VARIANCE APPLICATION

PROPERTY INFORMATION			
Project/Property Address: Hamilton Road		Project Name/Business Name: Orthopedic One Gahanna / Orthopedic One	
Parcel #: 025-013767-00	Zoning: (see Map) SCPD	Acreage: 9.13 ac

RE: Response Letter #1
Project Hamilton Rd Ortho One Final Development Plan

STAFF REPORT

LANDSCAPE PLAN - OVERALL SITE

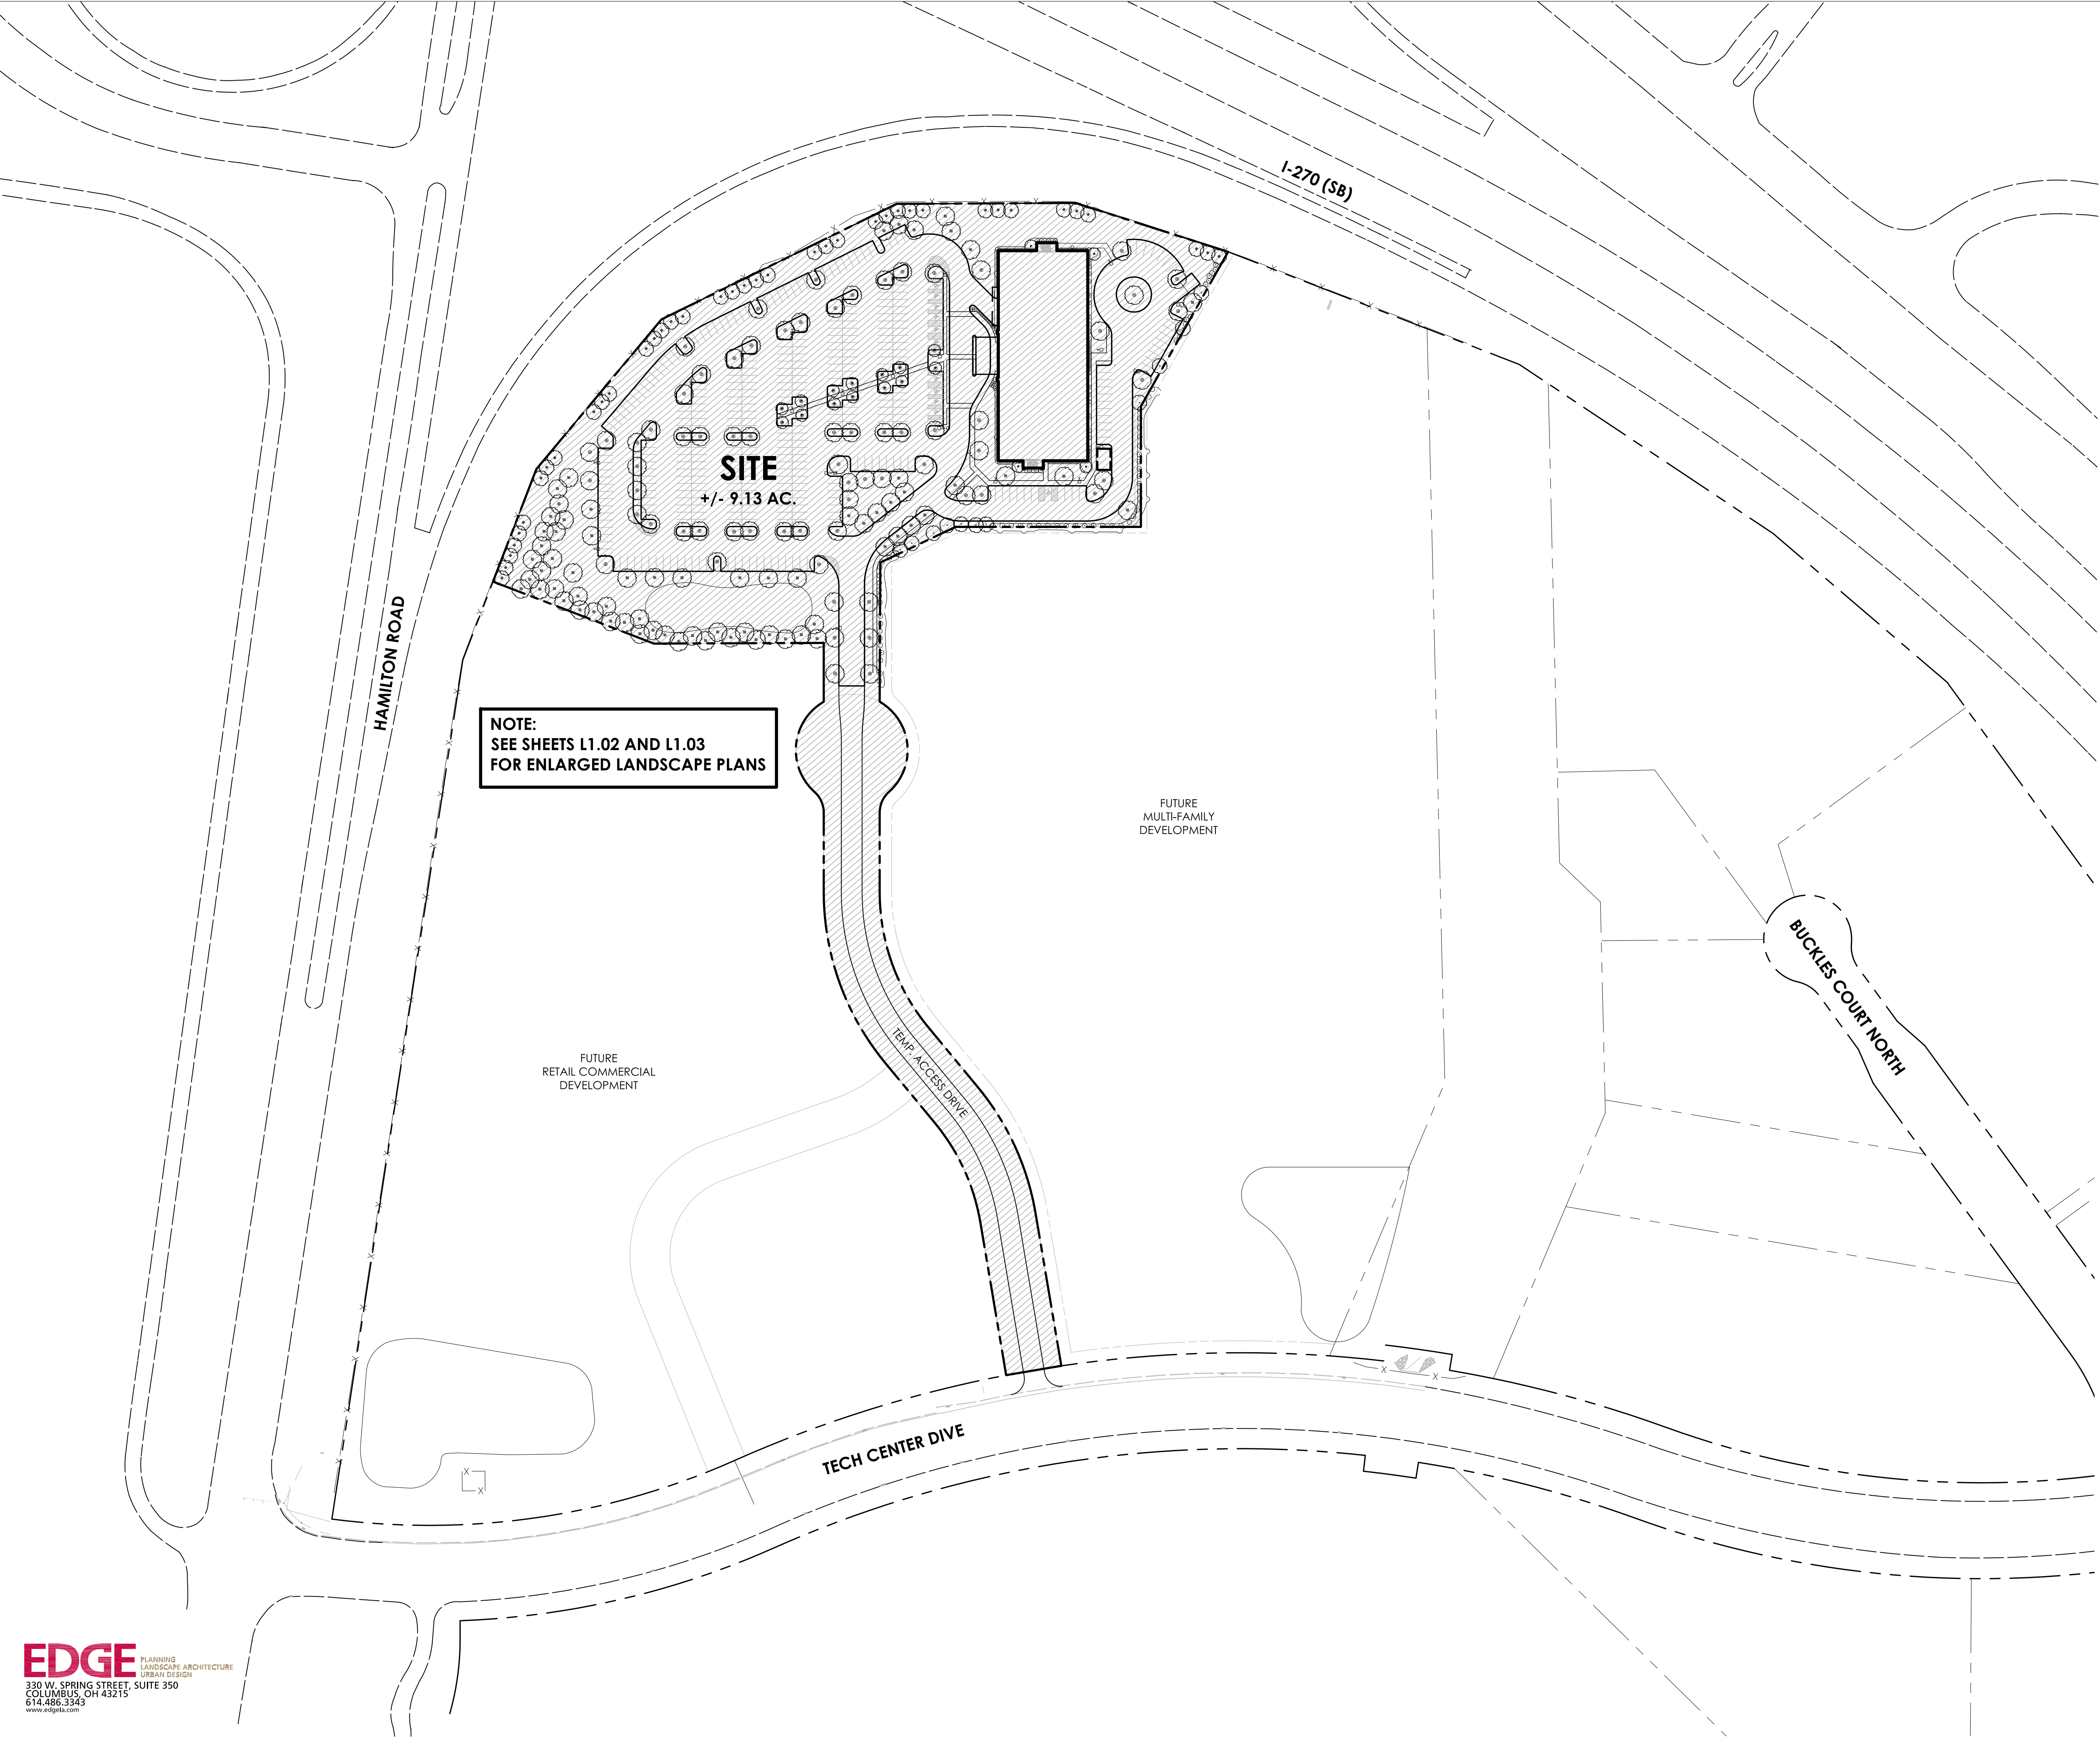
1163.08 (h) Interior Landscaping Requirements	There shall be a ten-foot wide island for every two rows of parking. The island shall have a minimum three-foot high screen between the two rows of parking. The screen may be comprised of mounding, evergreen planting or a combination thereof.	Not provided - <u>Variance Request</u>	
1167.18 (b) Screening Requirements	Adjacent to Residential Zones and Planned Development. The following list of activities, if developed adjacent to land in a residential zoning district, shall be screened as prescribed, except that it is separated by a street right-of-way eight feet or more in width. A parking area of 1,000 square feet or more provided or intended for five or more vehicles for commercial and industrial establishments.	<u>Variance Request</u> to provide 50% of required plants with adjacent residential site as noted below for 1167.20(b)(1) 11 trees (2" cal.) and 6' high planting provided

1167.20 (b)(1) Property Perimeter Requirements	Any residential zone adjoining any office zone, required buffer zone is 15 feet adjacent to all common boundaries except street frontage and shall include one tree for each 40 feet of linear boundary, or fraction thereof, and a continuous six-foot-high planting, hedge, fence, wall or earth mound. 883 LF of boundary adjacent to residential / 40 = 22 trees required	<u>Variance Request</u> to provide 50% of required plants with adjacent site. 11 trees (2" cal.) and 6' high planting provided	
1167.20 (b)(7) Property Perimeter Requirements	Any zone adjoining a freeway or arterial street prohibiting driveways. Required buffer zone is 20 feet for residential zones and 15 feet for all other zones adjacent to a freeway or arterial and shall include one tree for each 30 feet of linear boundary, or fraction thereof, and a continuous six-foot-high planting, hedge, fence, wall or earth mound. 1,147 LF of freeway and arterial frontage / 30 = 38.23 or 39 trees required	<u>Variance Request</u> to provide 39 trees (2" cal.) without continuous six-foot-high planting, hedge, fence, wall or earth mound.

Submitted Site Plan

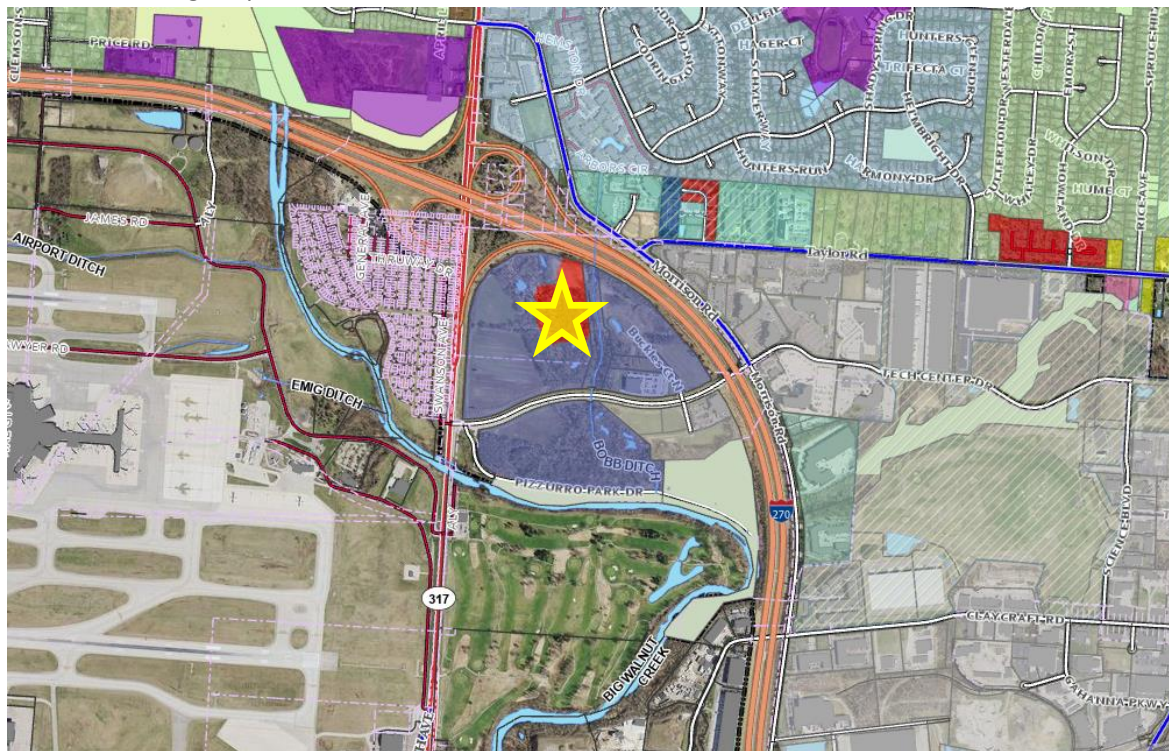
1. 1151.04(b)(14) – Development Standards
 - a. Code requires a 25-foot setback for parking areas adjacent to residential zones.
 - b. Staff does not object to the variance request. This is a request to reduce the setback to 7 ft. Buffering and screening is provided on this site and the adjacent site.

2. 1163.08(h) – Interior Landscaping Requirements
 - a. Code requires a ten-foot-wide island with three-foot-high screening for every two rows of parking.

- b. Staff does not object to the variance request. This is a commonly approved variance request, and this requirement is in the process of being removed from Code.

3. 1167.18 – Screening Requirements
 - a. Parking areas adjacent to residential zones shall have screening that is 6-8 ft in height and 80% opacity.
 - b. Staff does not object to this variance request. Landscaping and screening requirements are being coordinated with the adjacent residential site. There will be buffering on both sites to create continuous screening.

4. 1167.20(b)(1) – Property Perimeter Requirements
 - a. Any residential zone adjoining an office zone requires a 15 ft buffer, one tree per 40 ft of linear boundary, and a continuous six-foot-high screen.

- b. Staff does not object to this variance request. Partial screening will be achieved on-site through trees and shrubs. Landscaping and screening requirements are being coordinated with the adjacent residential site. There will be buffering on both sites to create continuous screening.

5. 1167.20(b)(7) – Property Perimeter Requirements
 - a. Any zone adjoining a freeway requires a 15 ft buffer, one tree per 30 ft of linear boundary, and a continuous six-foot-high screening.

- b. Staff does not object to this variance request. The applicant would like the site to maintain visibility along roads and freeways.
